RFQ NUMBER
708EC004

ADDENDUM #1

5 CUBIC YARD STAINLESS STEEL (HYDRAULIC) SPREADER

CHANGES TO SPECIFICATIONS:

Wiring Code 7 way Trailer End

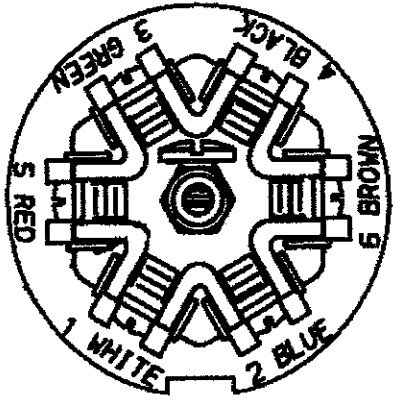
7.11 Lighting to be in accordance with the attached sketch.

7.11 Lighting to be in accordance with the attached sketch and wiring schematic

#	Color	Gage	Circuit Function	connector interior
1	white	10	common ground	
2	blue	12	<i>STROBE</i>	
3	green	14	tail/running lights	
4	black	10	battery charge (+)	
5	red	14	left turn/stop	
6	brown	14	right turn/stop	
7	yellow	14	auxiliary/ Work <i>Lights</i>
